Swan_soundbar

DVT3_Assembly review

ALT Co., Ltd.

Issued Date 2021.08.30

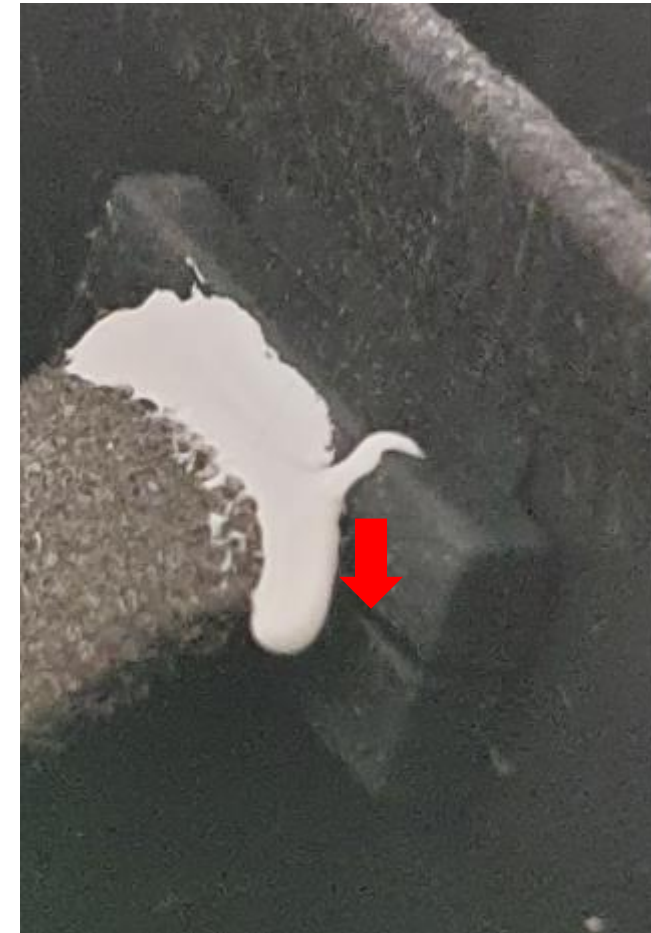
- Assembly - Defect

- Glue apply defect

- Recommend the Change glue materials : DOWSIL_7091

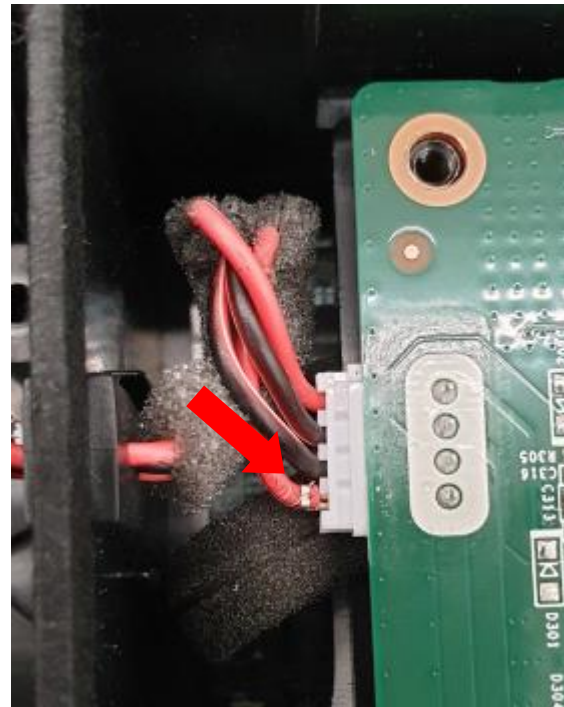
• Assembly – Speaker Defect

- Please tug test on IQC
 - From 1st MP to 15K production
 - Due to cable pin reworked.

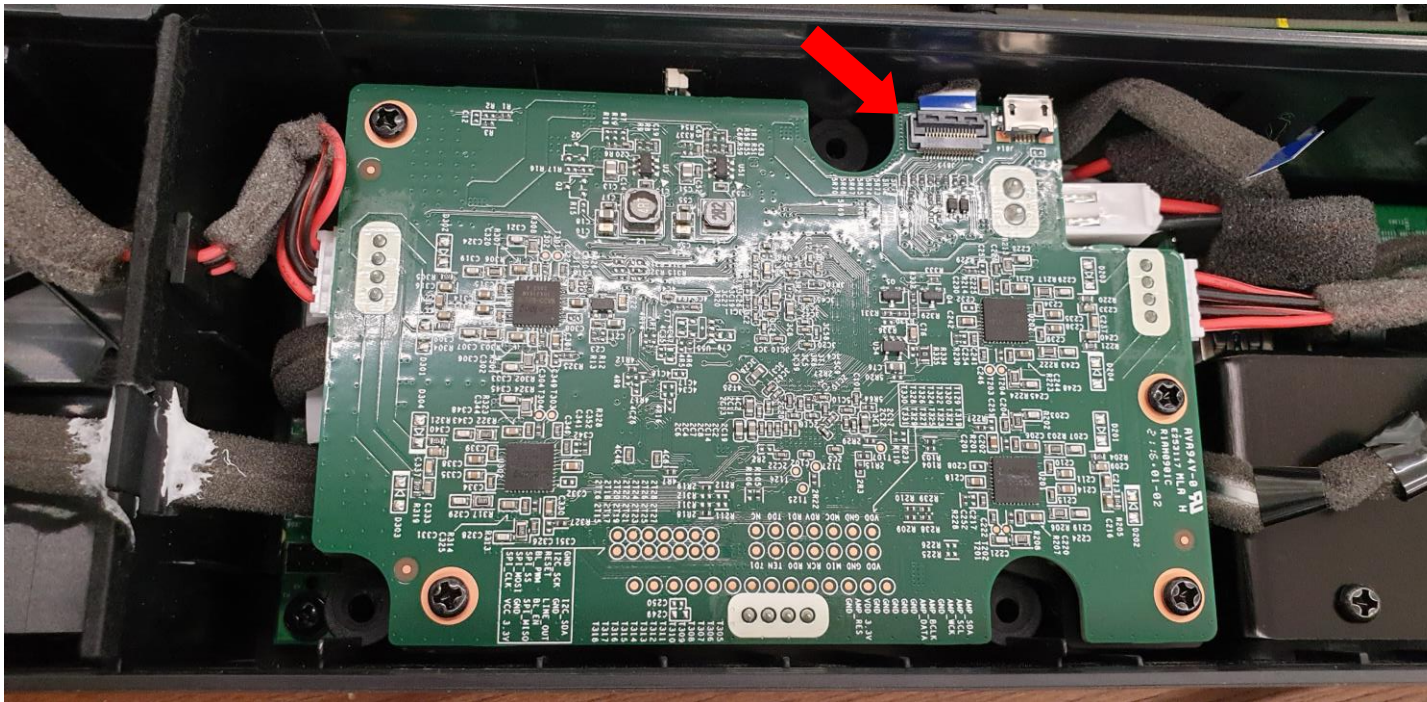
- Assembly - Defect

- Screw cover assembled under foot

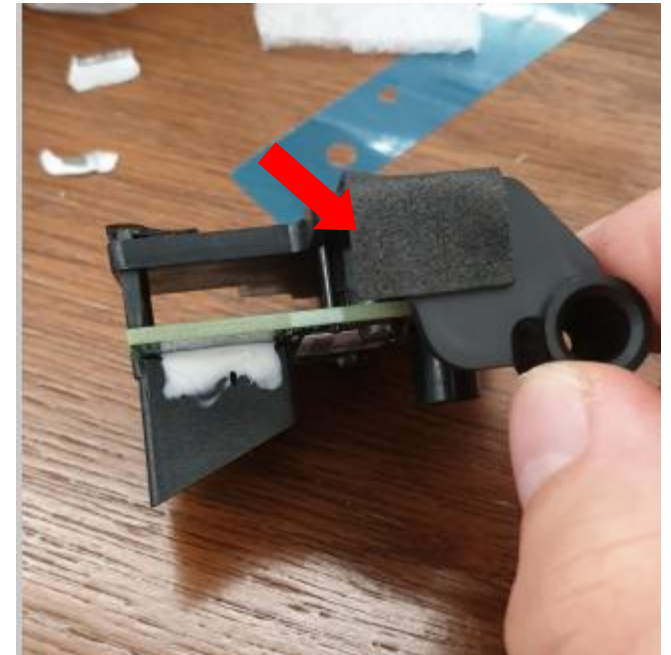
- Assembly - Defect

- Gasket attachment NG
 - Gasket should be cover bottom side

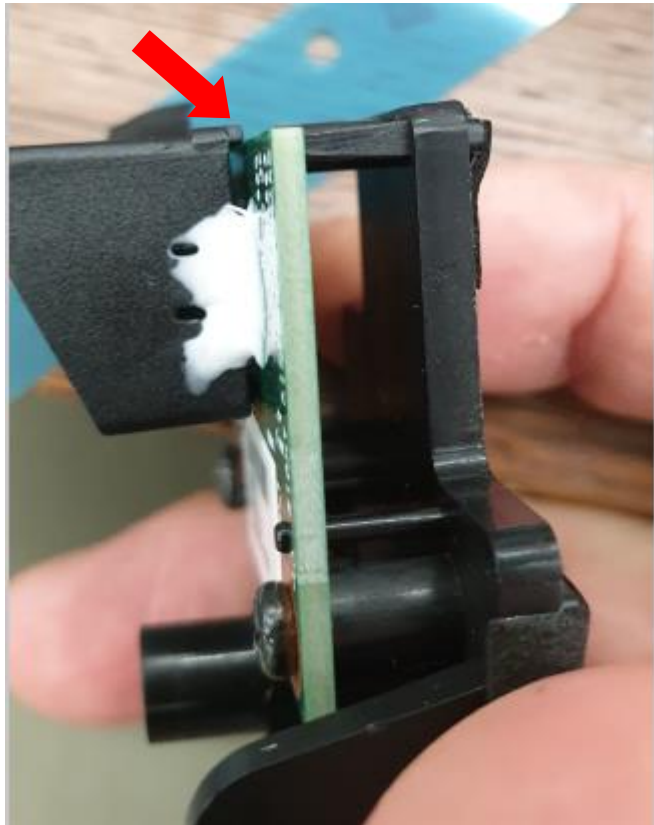
• Assembly - Defect

- Light pipe assembly NG
 - Light pipe is not fully inserted.
 - Not detected next operation – apply glue

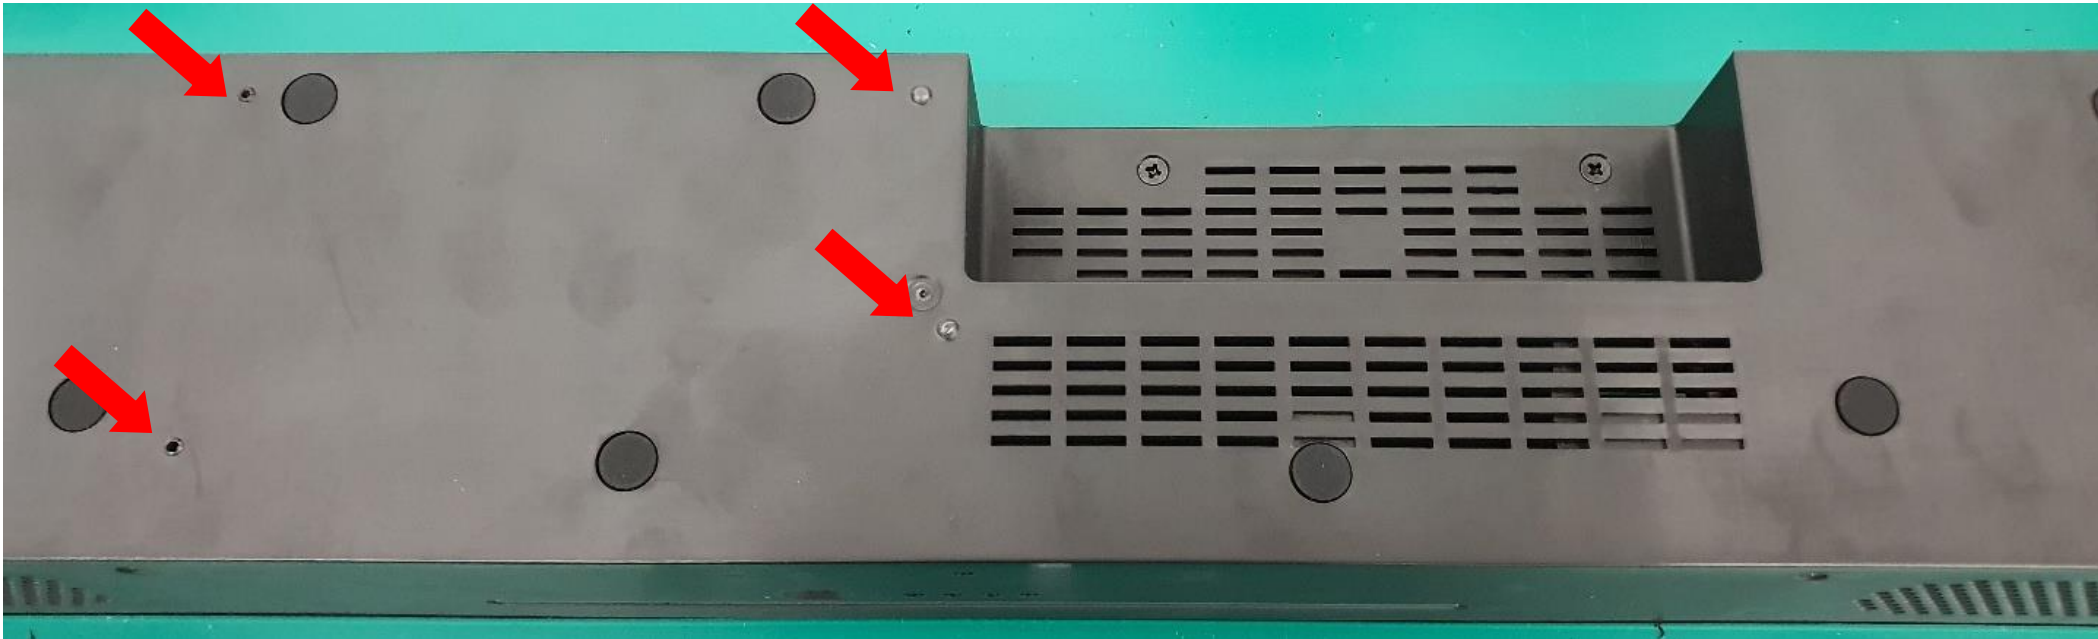
- Wrong screw assembly
 - Damage the bottom housing
 - The screw should be apply M3*7
 - But assembled M3*10 screw

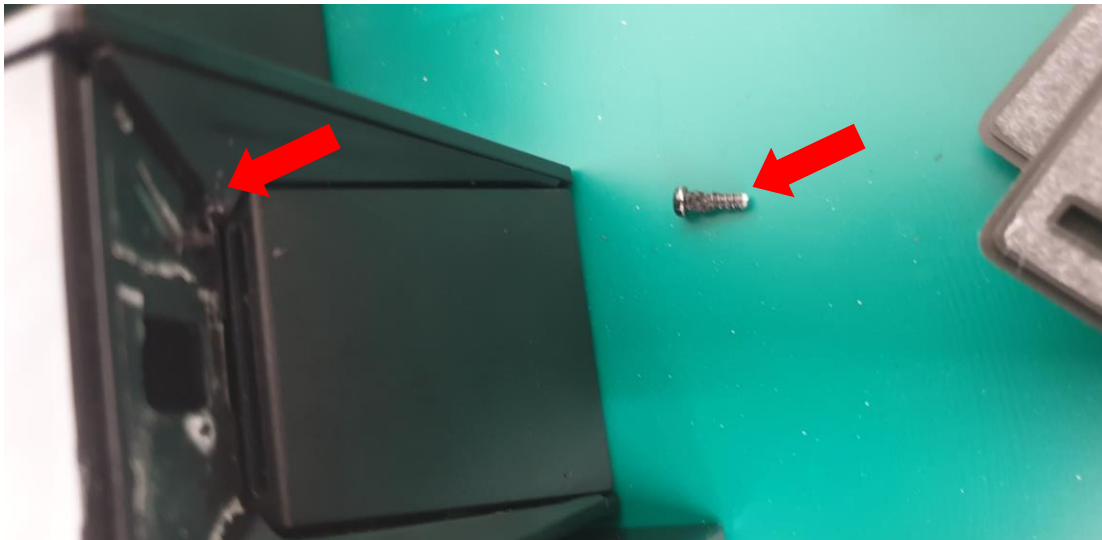
- Wrong screw assembly
 - The screw should be apply M3*7
 - But assembled M3*10 screw

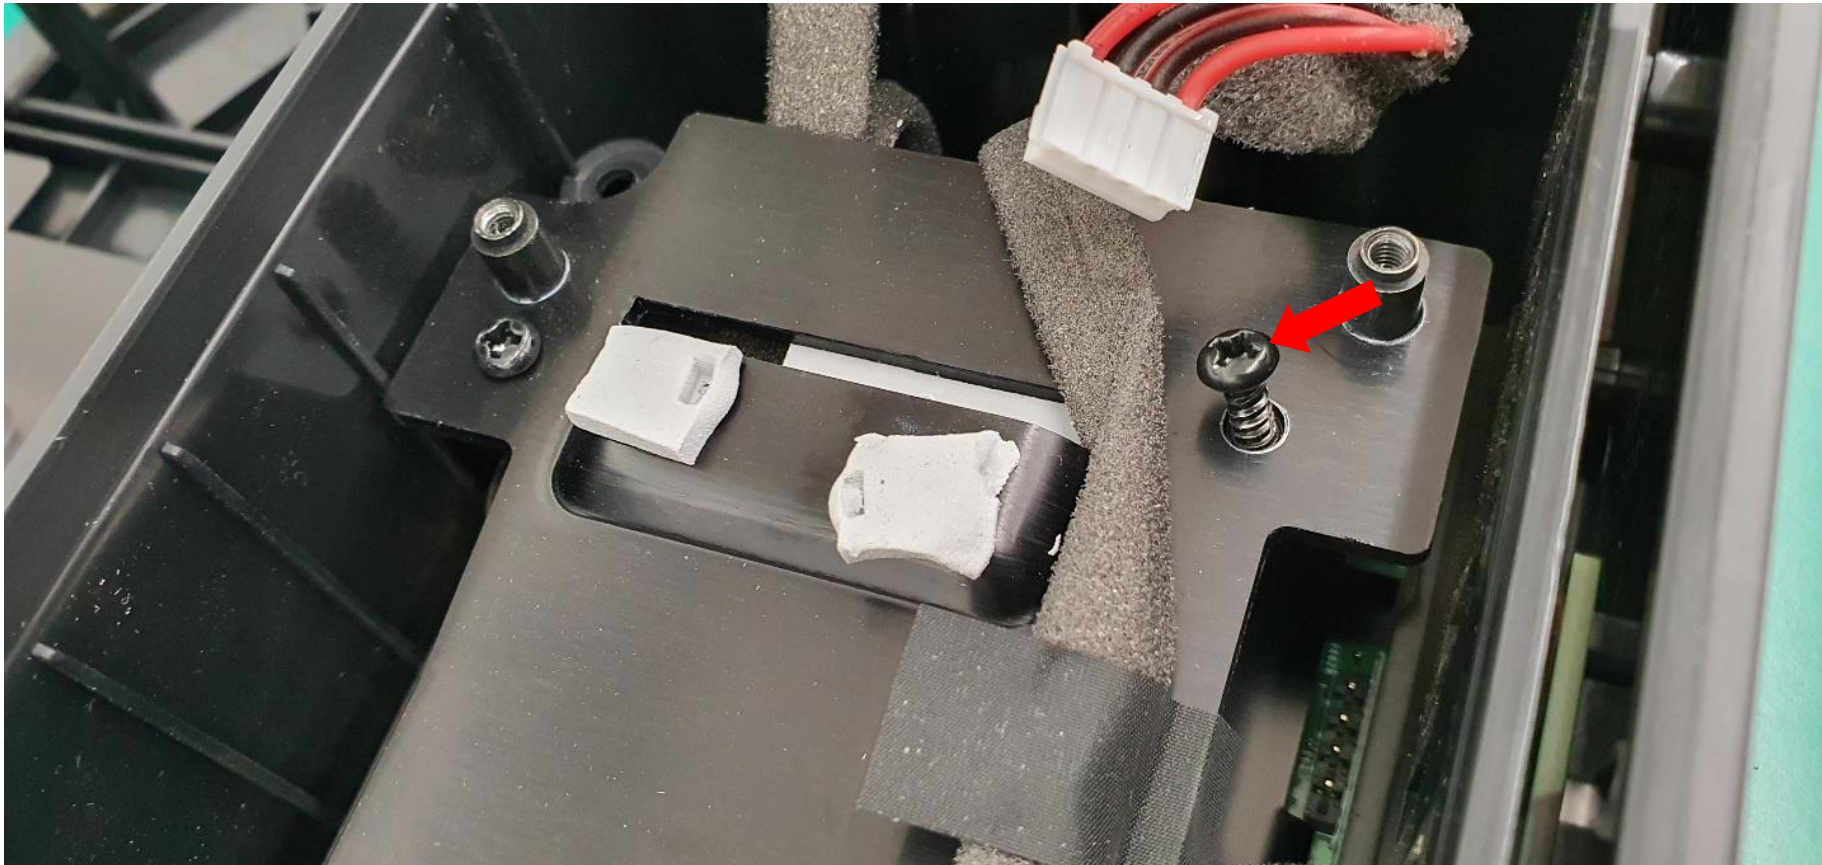
- Wrong screw assembly
 - assembled with the wrong type screw

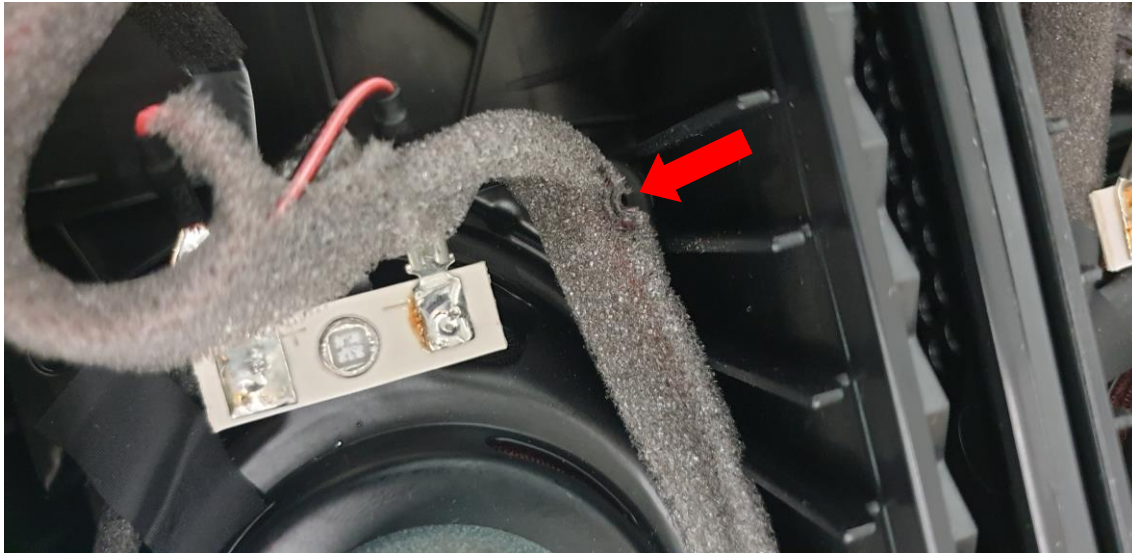
- Cable routing defect

- The cable is damaged due to screw lock up

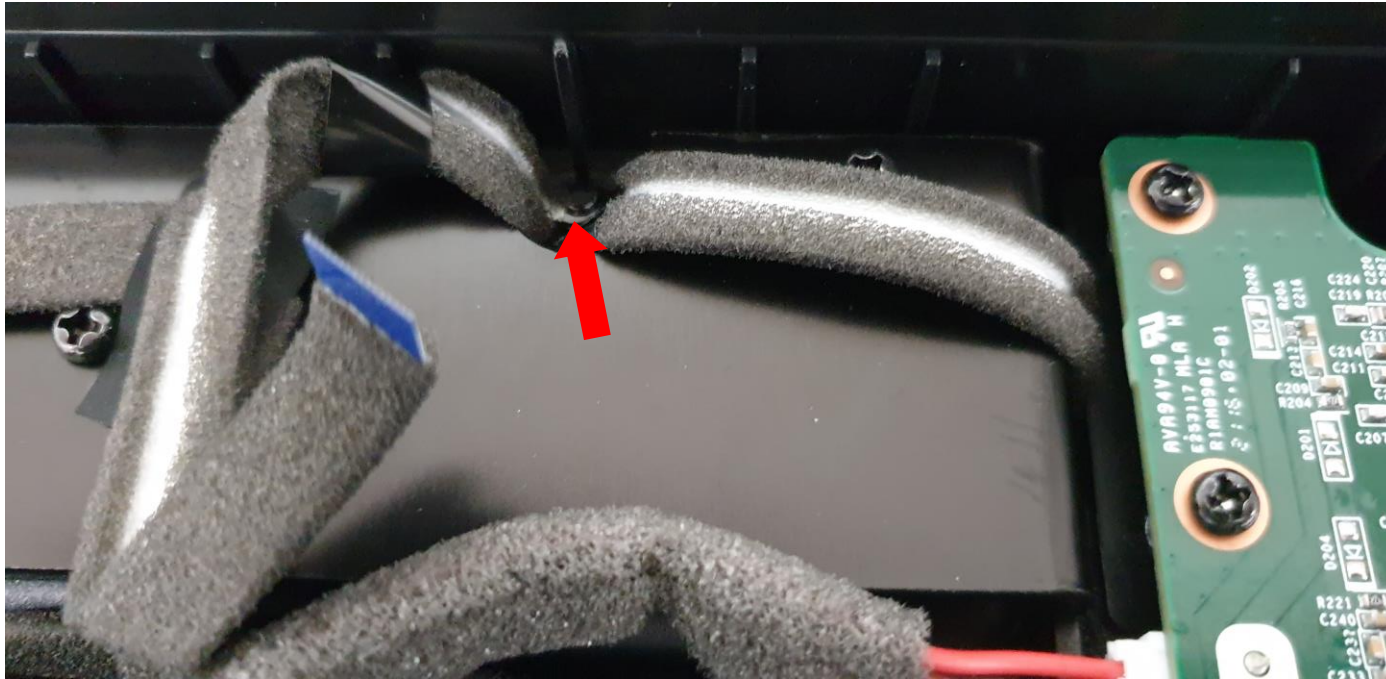
- Cable routing defect

- The FFC cable is damaged due to screw lock up

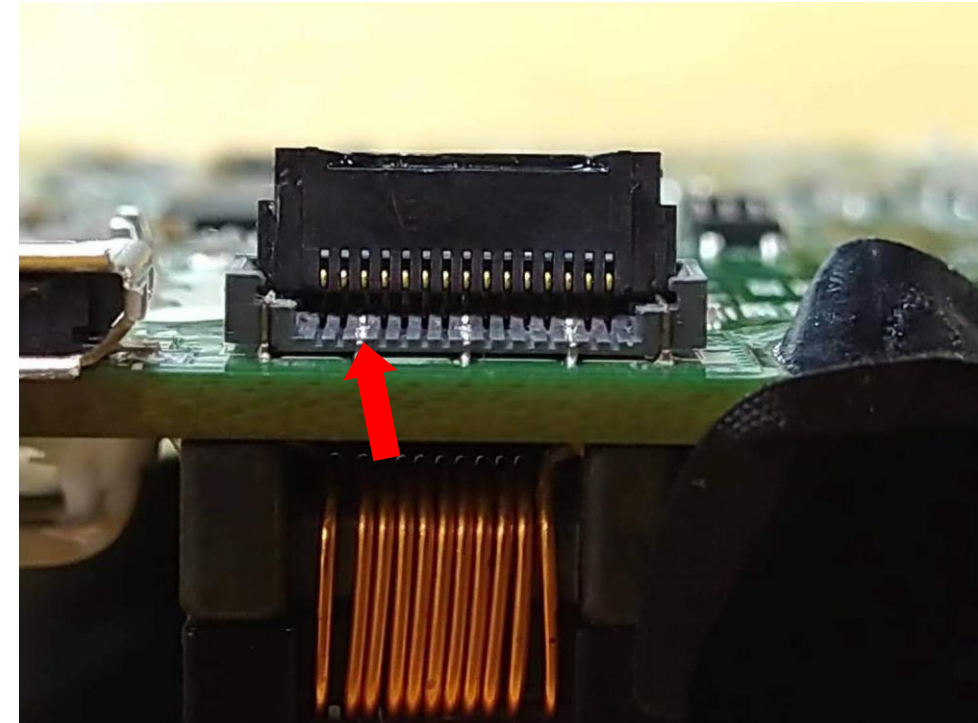
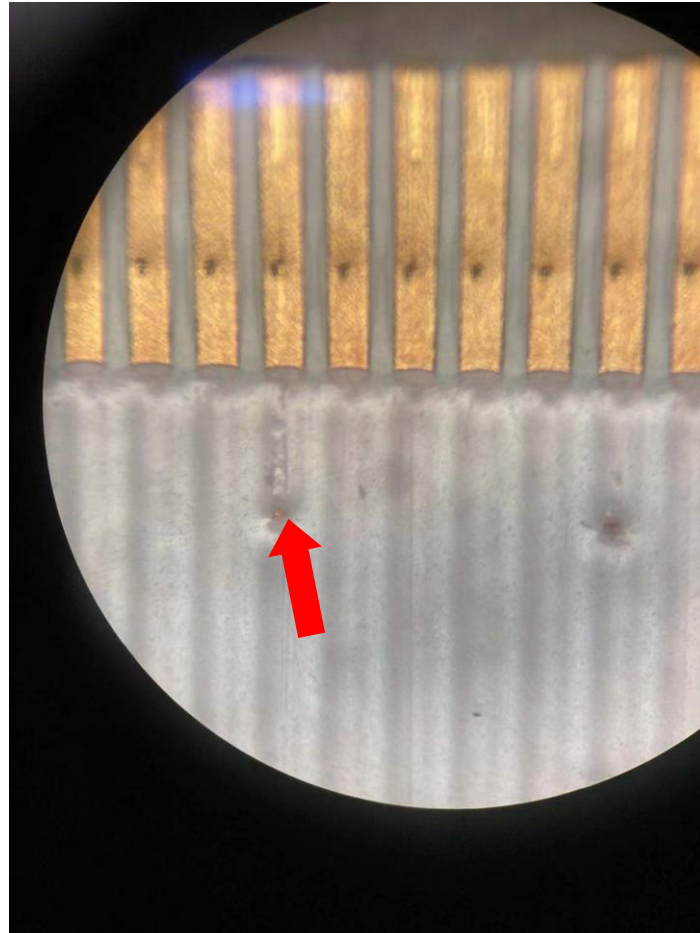
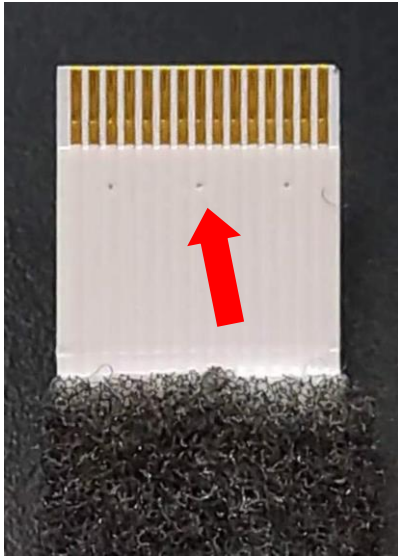
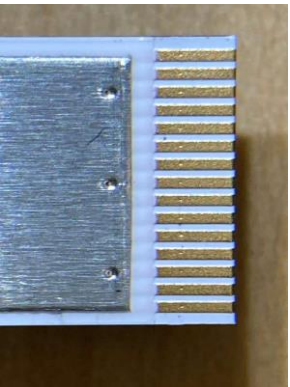
• FFC Cable damage

- The AMP FFC cable is damaged due to FFC Connector
- I2C short defect caused by this issue

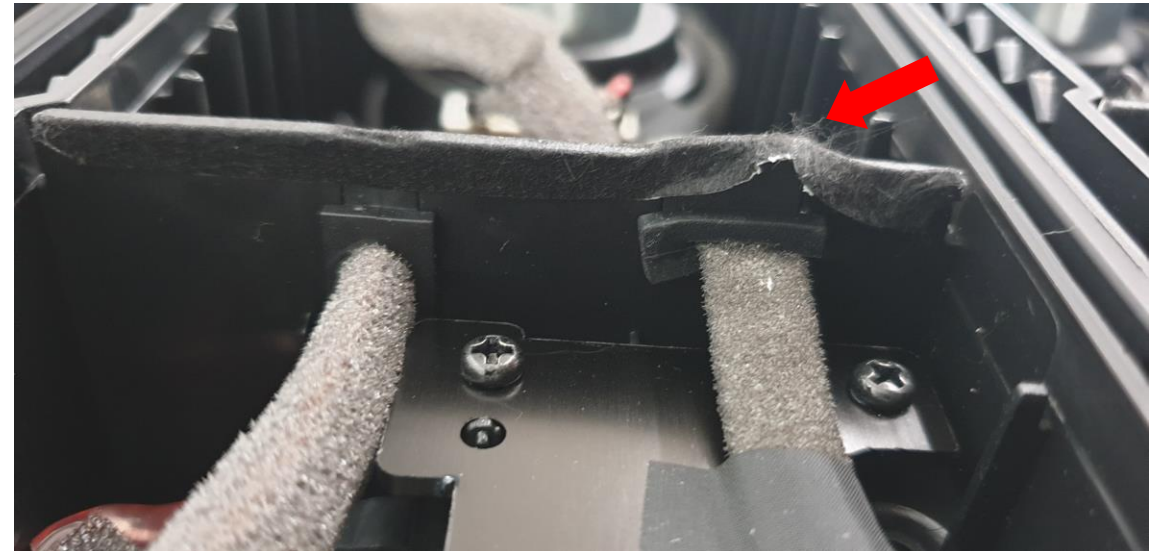
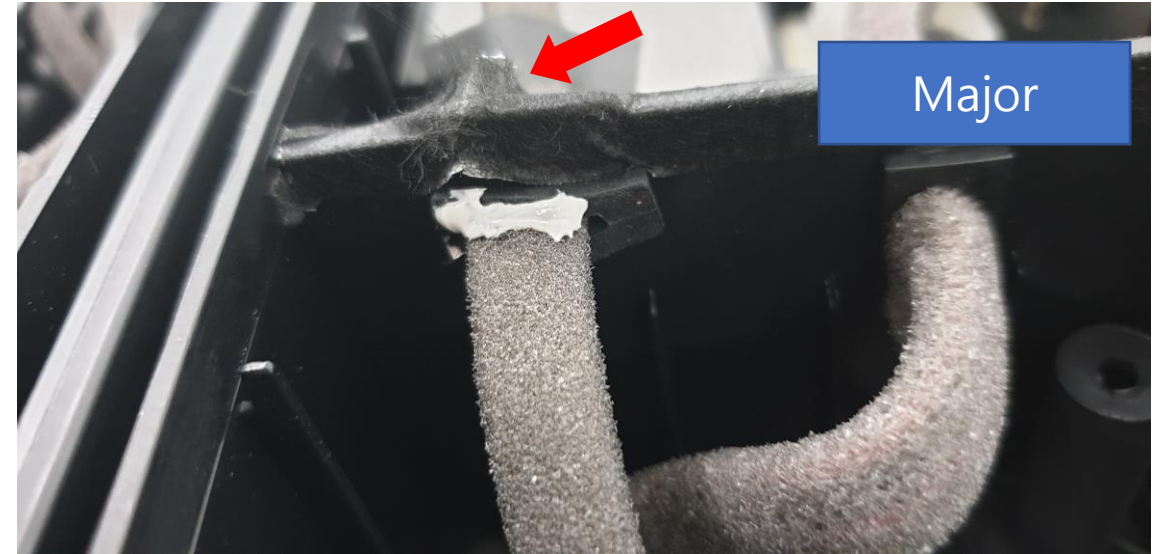
- Inner bushing assembly NG
 - The bushing is incorrectly assembled.
